Docket Item # 4 & 5
BAR CASE # 2012-0196 &
2012-0197

BAR Meeting
July 11, 2012

ISSUE: Partial Demolition/Capsulation and Alterations

LOCATION: 312 Queen Street

AREA OF DEMOLITION & ENCAPSULATION ~ EAST ELEVATION

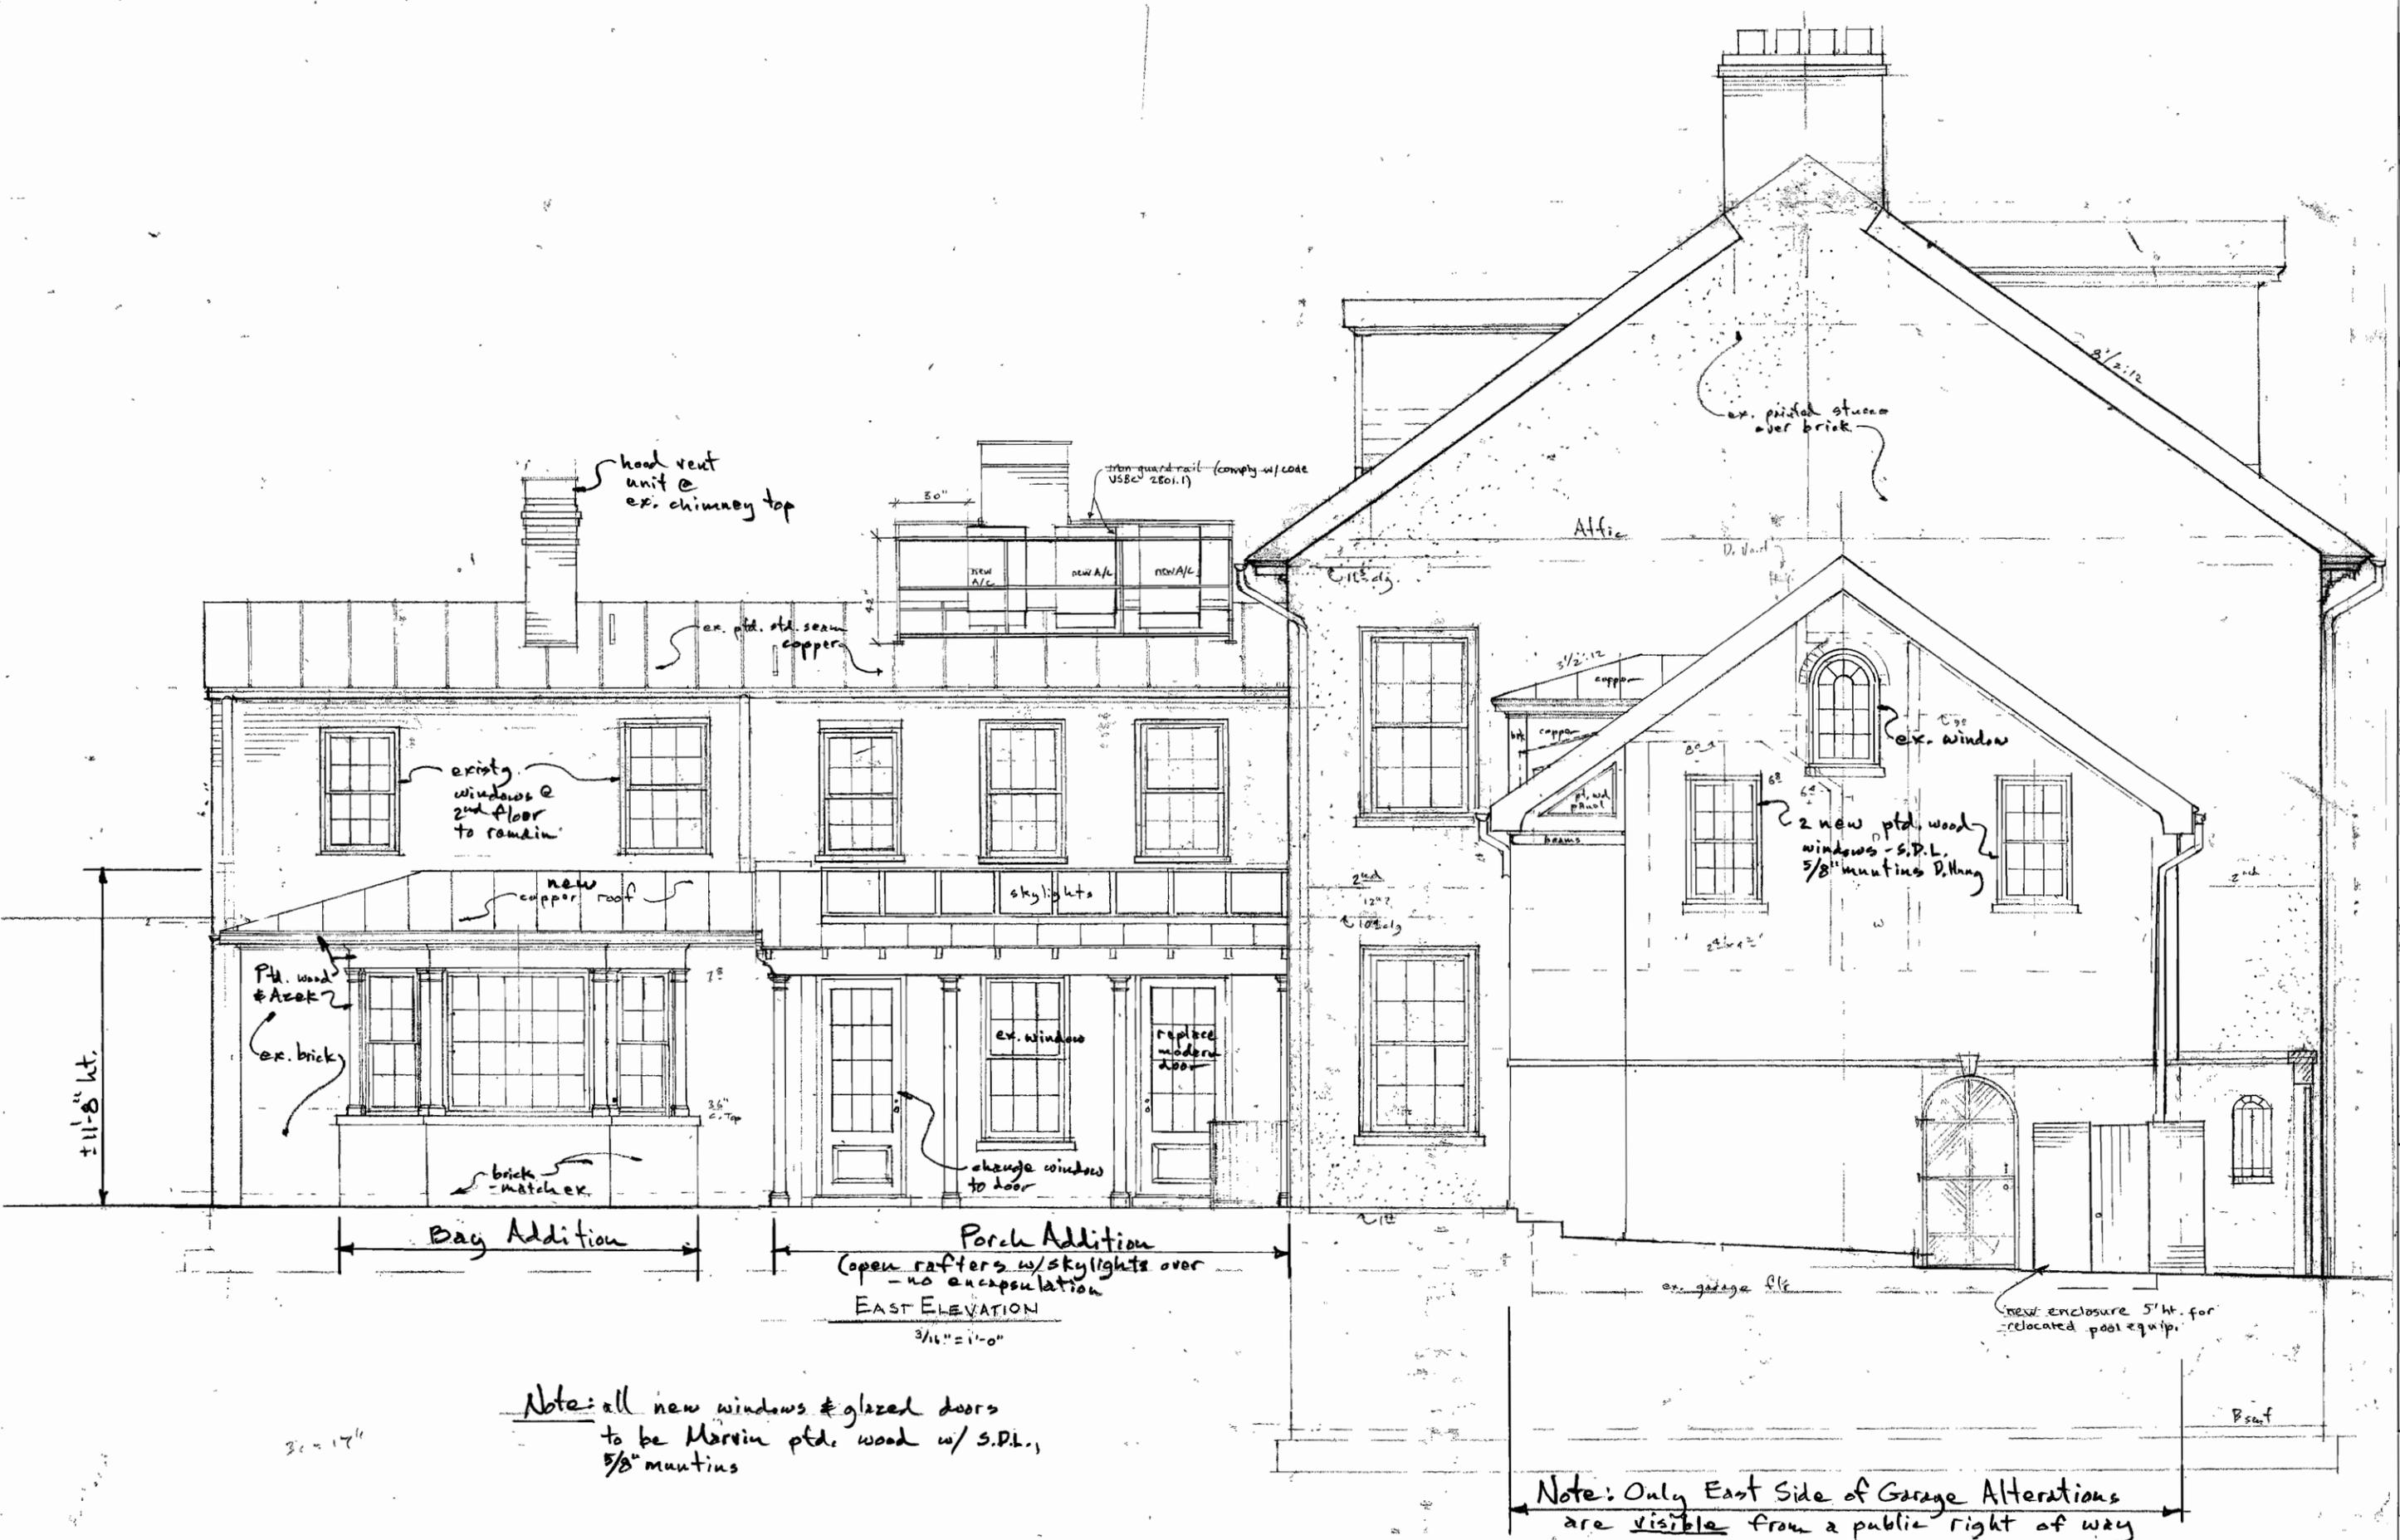
- Demolish existing one-story shed addition attached to east elevation of rear ell.
- Demolish existing dormer and portion of roof (39 square feet) on south (rear) elevation of garage.
- Demolish two 7.5 square foot areas for two new windows on east elevation.
- Demolish existing window and portion of wall on rear (south) elevation of rear ell (29 square feet).

In the opinion of Staff, the criteria to demolish and capsulate are not met and the Permit to Demolish should be granted. The Board regularly approves the partial demolition and capsulation of secondary elevations or later additions to allow for a new or larger rear addition or other alterations when the existing walls are not of particularly old or unusual construction. In this case, the majority of the existing original elements will remain visible and intact. The majority of the area proposed for capsulation is not original and has been clearly altered over time. Staff finds the cumulative amount of demolition and capsulation to be minimal in scope and not involving materials or details that are high quality or of unusual design.

SOUTH ELEVATION
3/16" = 1'-0"

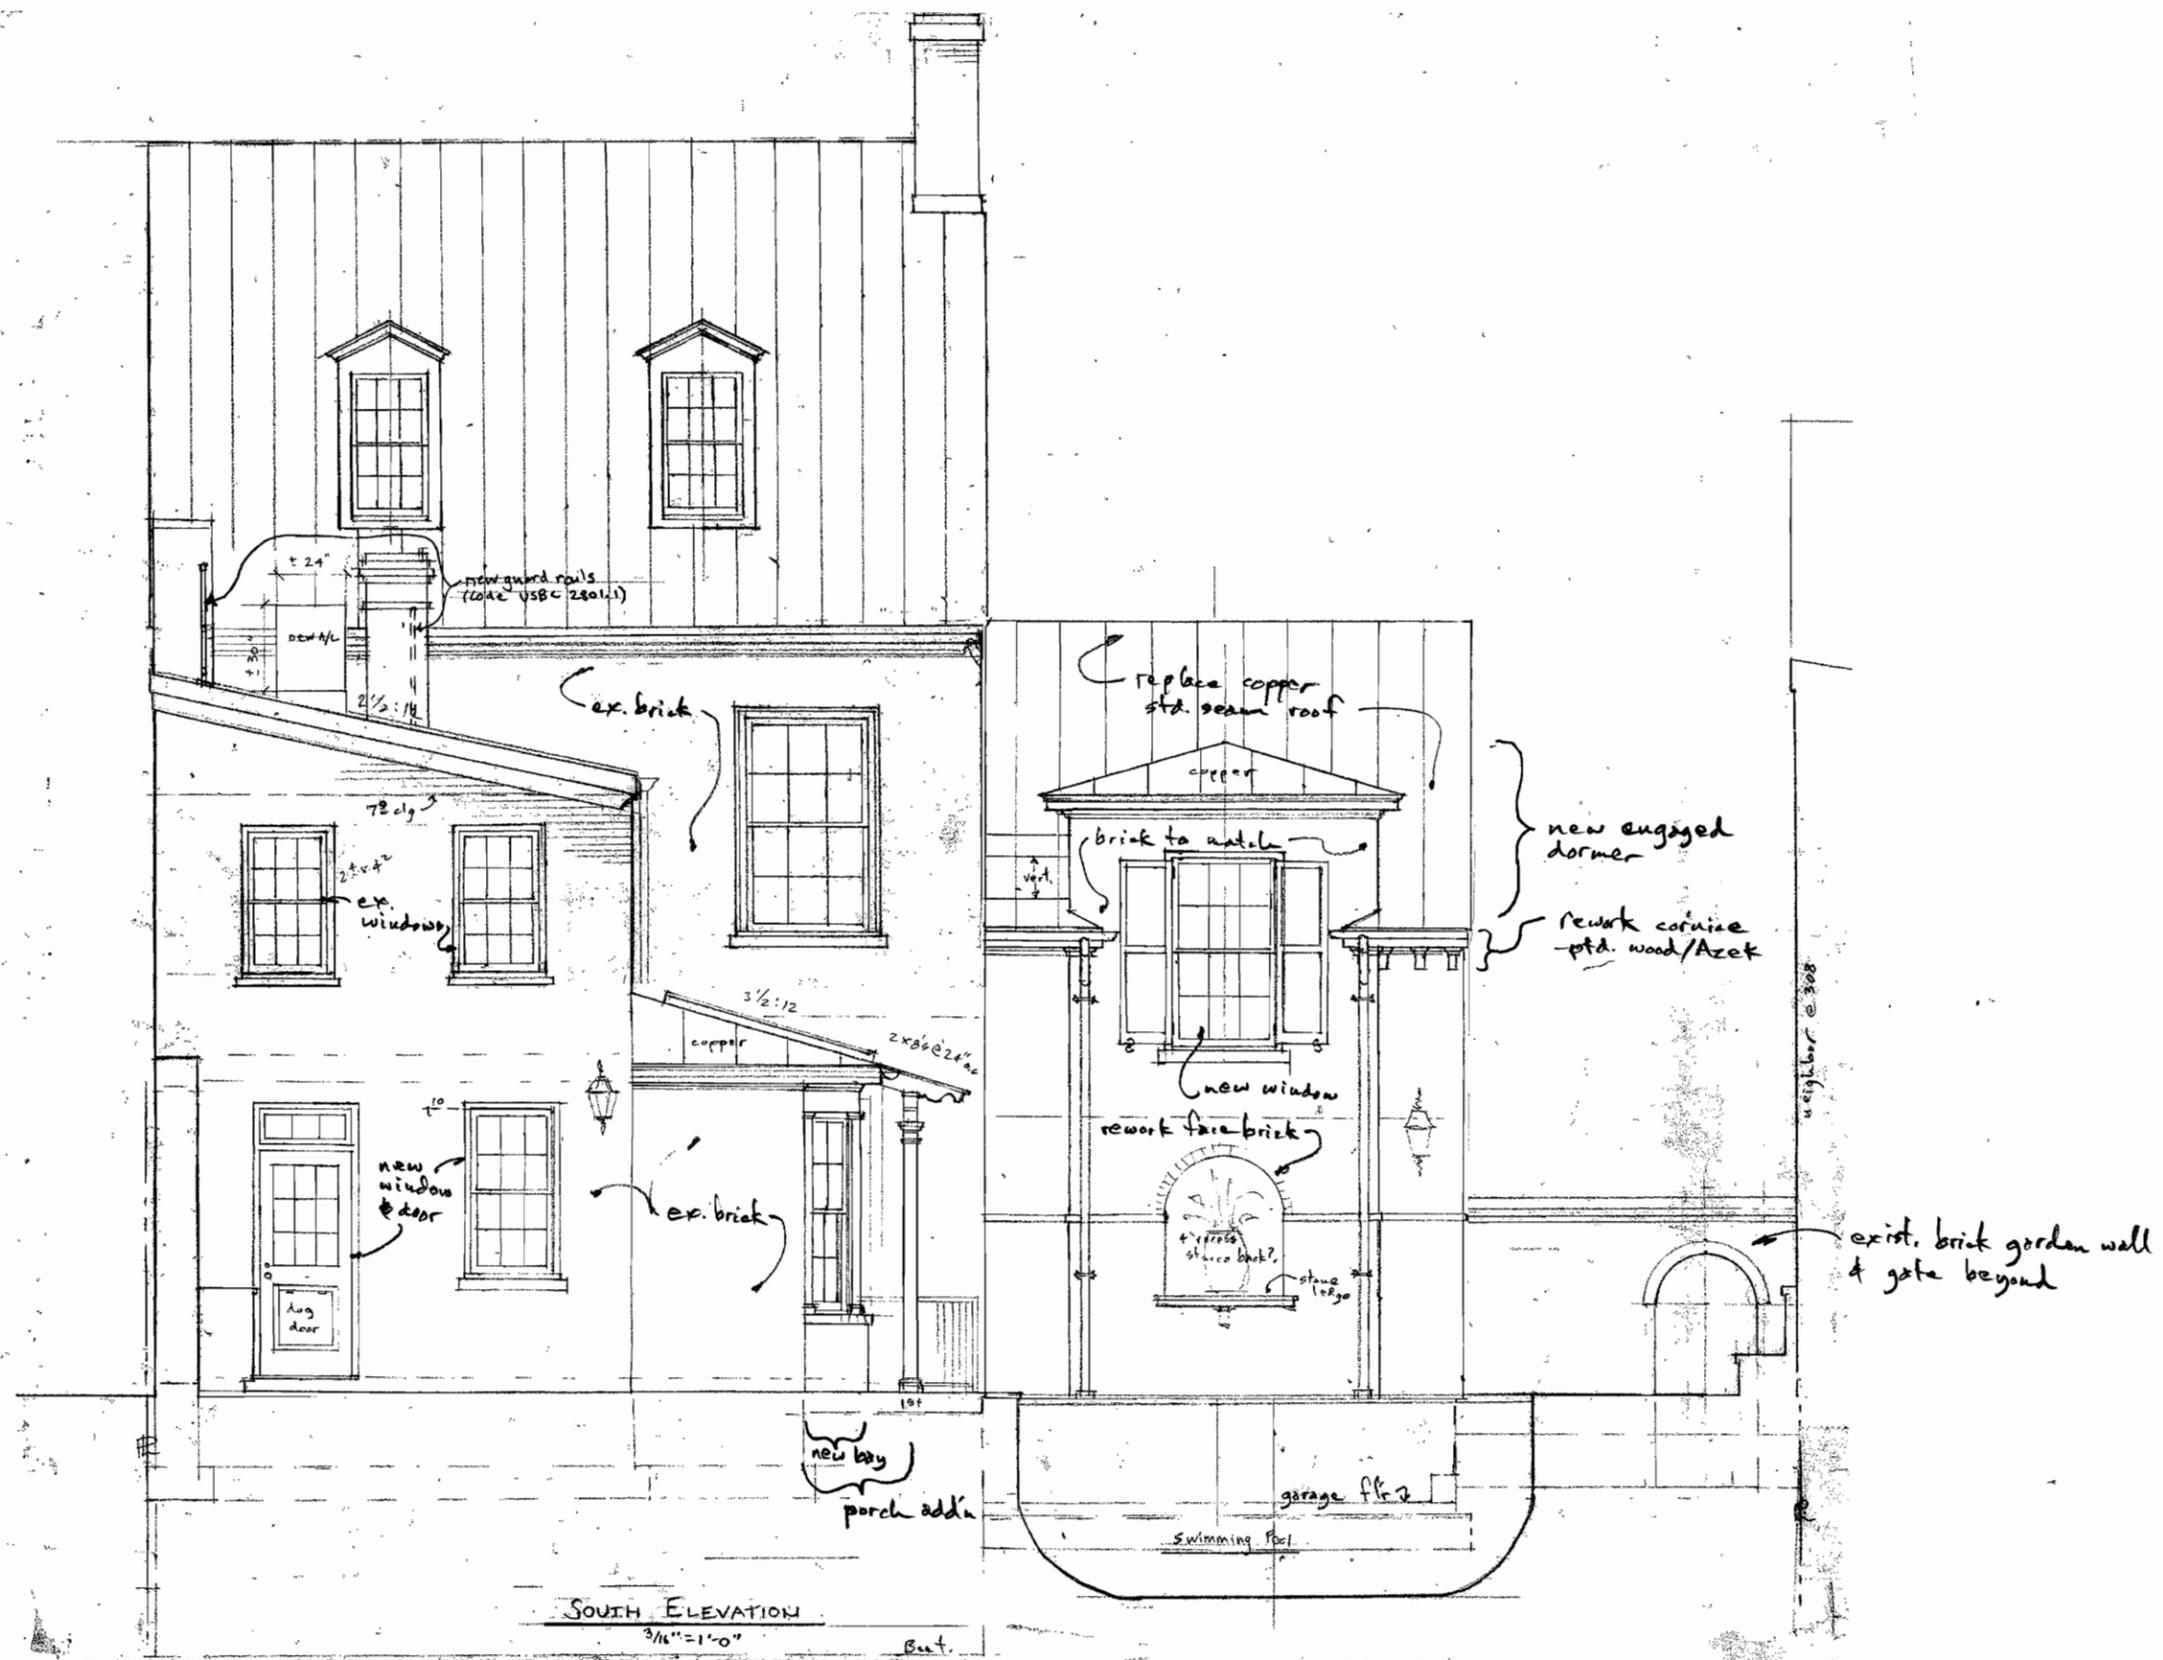
The only proposed alteration visible from a public way is the addition of two new windows on the south elevation of the existing garage. The addition of new windows is a common and typical alteration that allows existing space to be reconfigured for modern use. Staff finds this

alteration to be compatible with the existing garage and notes that this portion of the garage is a later addition. The main block of the historic townhouse will remain visually prominent.
